Re: Downhole commingling  
Desert Rose Federal #1  
Hess, East (Morrow) Field  
Bandana Point (Strawn) Field  
1740' FSL & 660' FEL  
Section 27-23S-23E  
Eddy County, New Mexico

Re: *Commingling Application  
Desert Rose Federal No.1*

Re: *Desert Rose Federal No.1  
Pressure Requirements for  
Downhole Commingling to be  
Approved Administratively*

*Re: Additional Information Required for  
Downhole Commingling Application*

# PRESSURE - PSIG

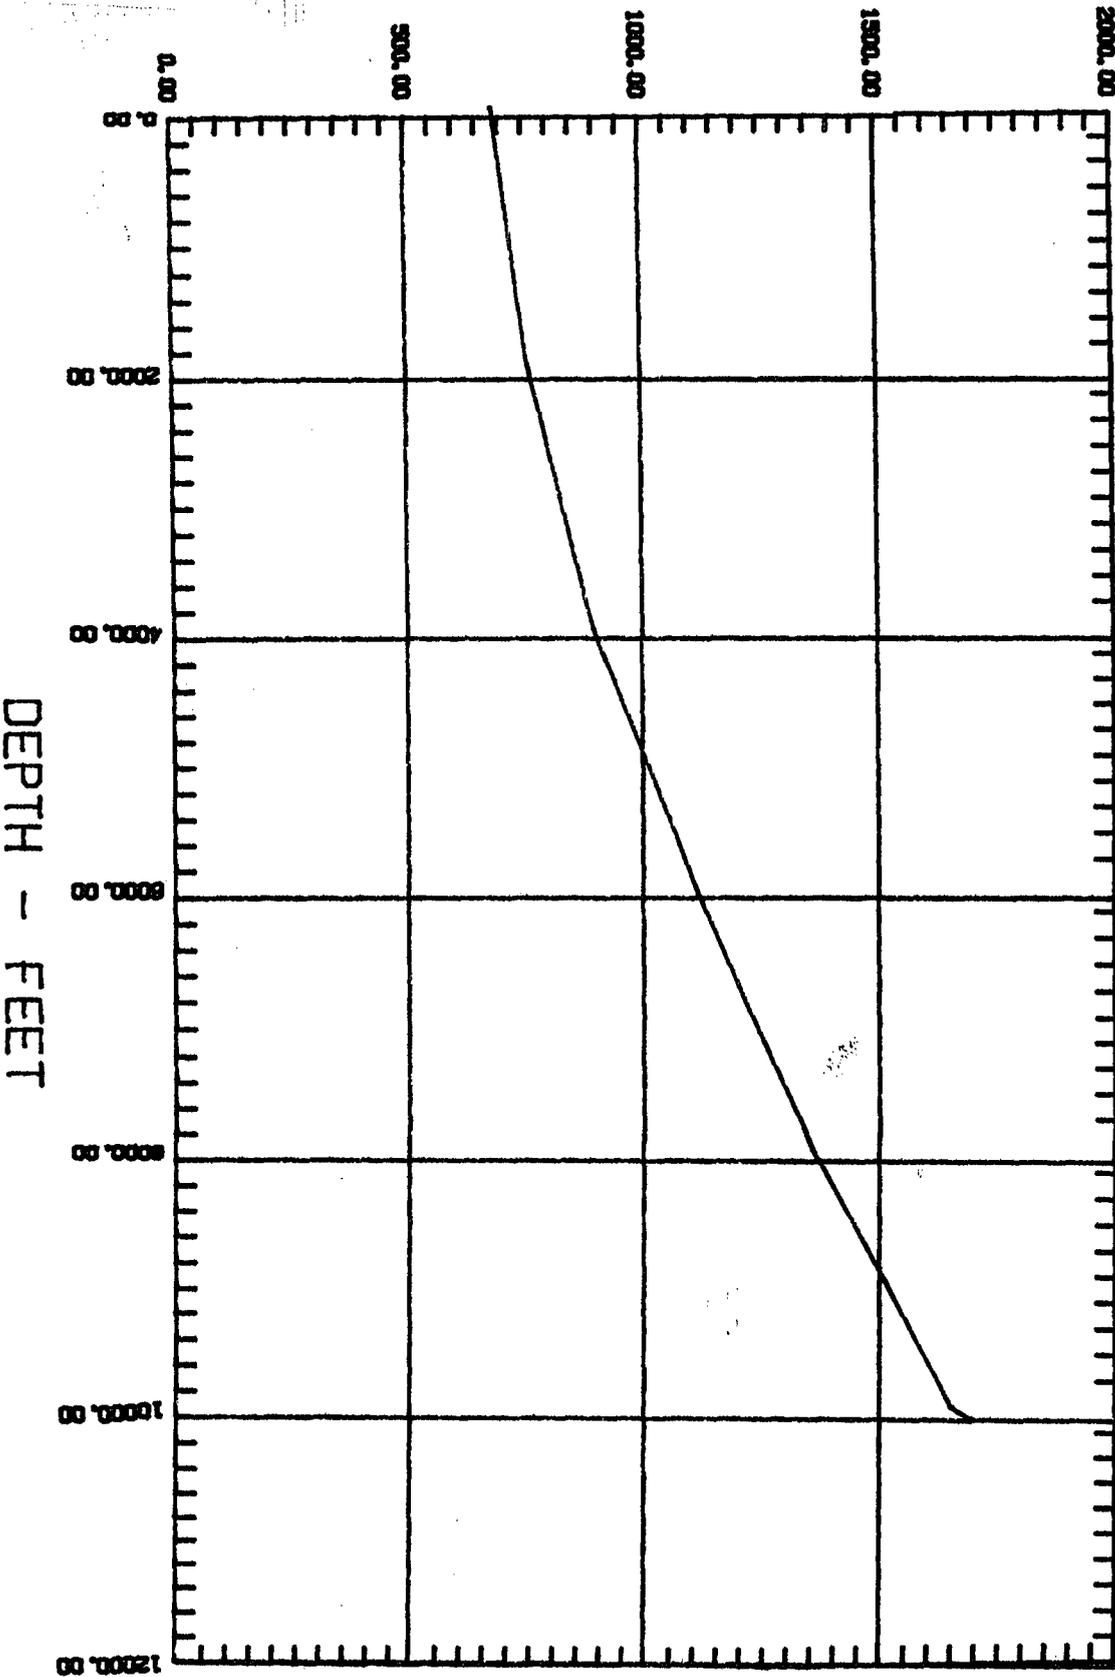
Your letter of December 16, 1993 requests that the bottomhole pressure data be supplied. The best available data on the Morrow formation is from Lonesome Dove Federal #1 located in Sec 26, T-23-s, R-23-E. This well had a bottomhole pressure of 1695 psig on November 30, 1993. A copy of this pressure data is attached and supports our statement that the Strawn and Morrow pools have less than a 50% differential in pressure. As you know, the actual pressure in the Desert Rose Fed #1 cannot be measured due to a leaking packer.

1000  
Leases **DESERT ROSE FEDERAL**

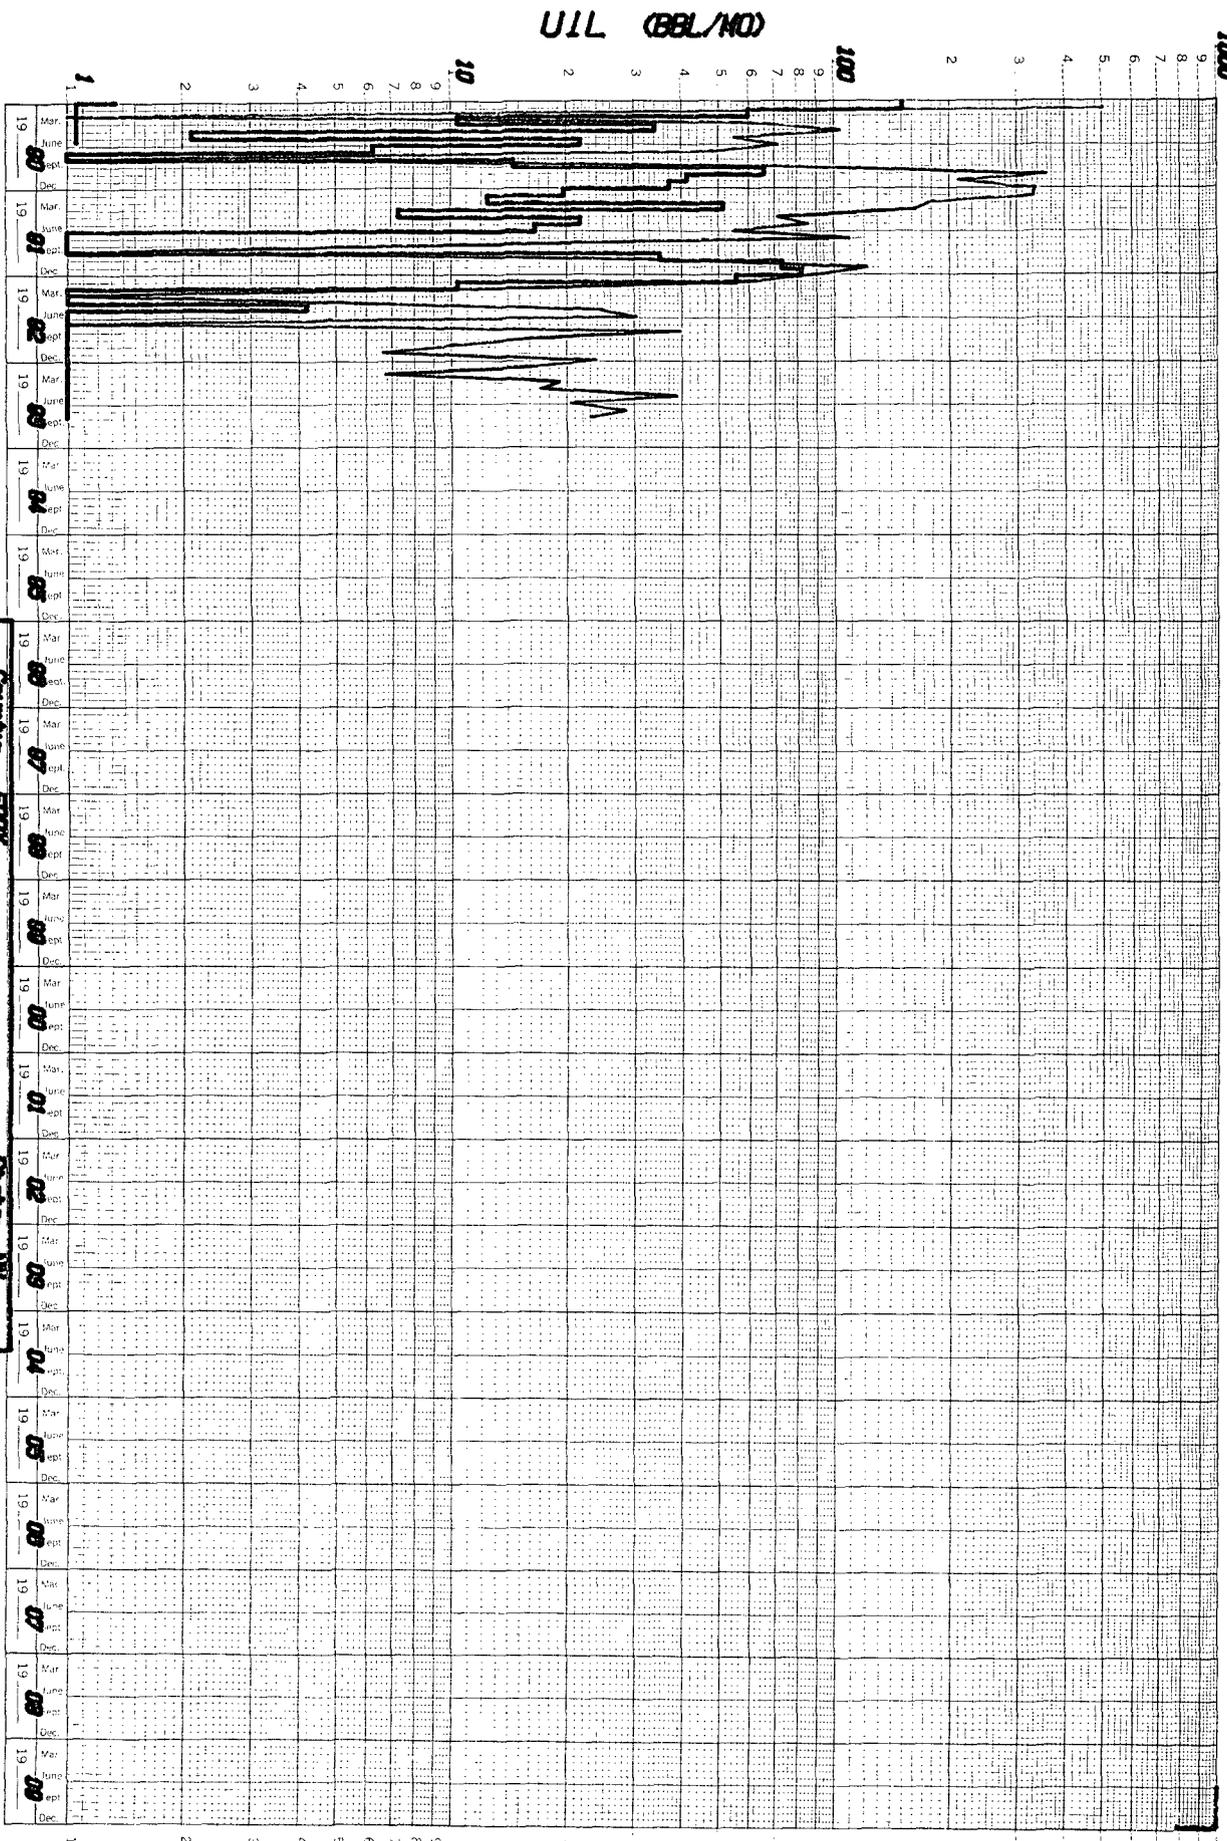
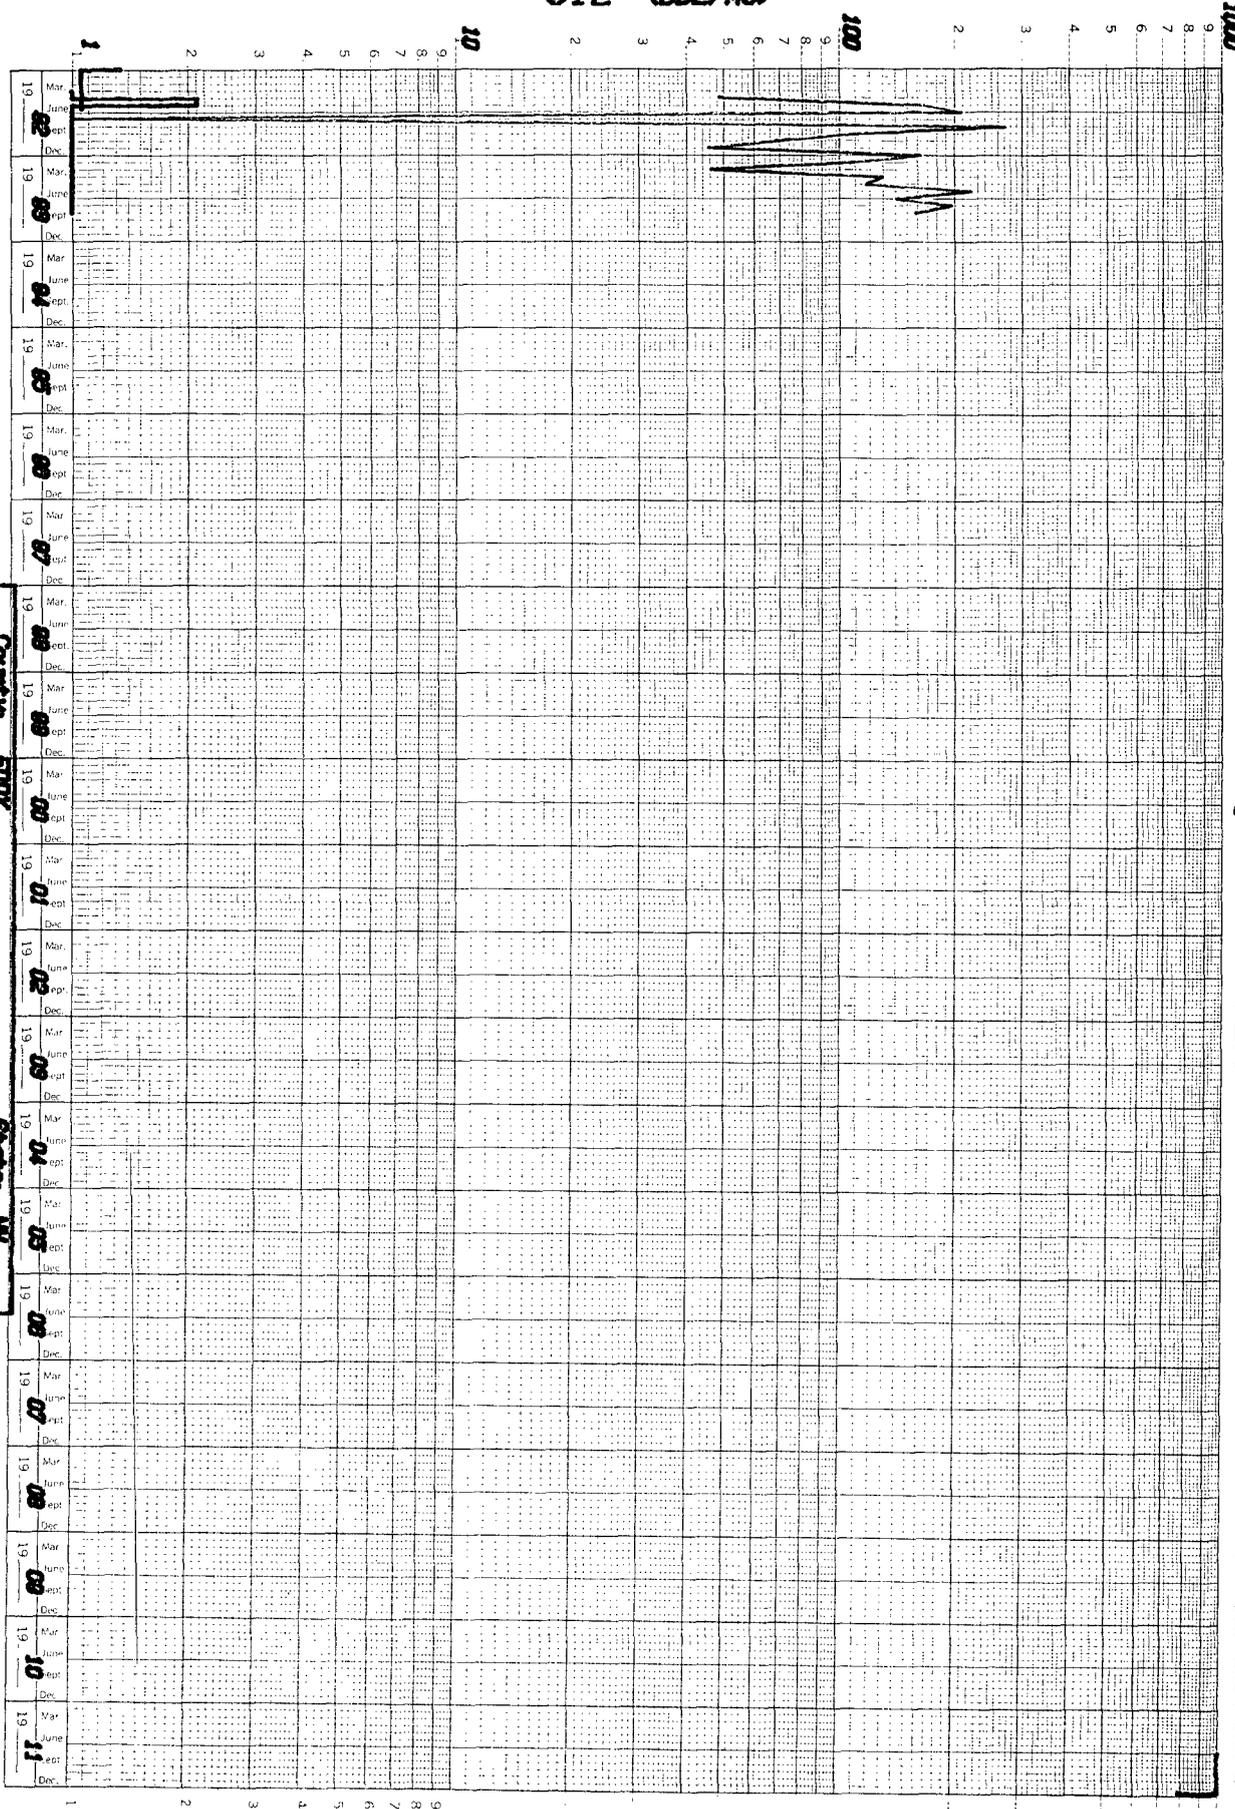
The statement that future gas production will be allocated based on a split of 41% for the Morrow and 59% for the Strawn is based on the current split of this production. This is the same split that has been used since June, 1992. Again, it is impossible at this time to determine a new basis for a split, due to the packer leak.

Attached are production decline curves showing a stabilized decline on both zones. We have determined that the future allocation could be based on a split of 41% for the Morrow zone and 59% for the Strawn. We have also attached a plat showing that OXY USA Inc. is the only offset operator. Correspondence has been sent to OXY notifying them of our intent and requesting a waiver. The waiver will be forwarded to you after receipt. We have also notified the BLM of our intent.
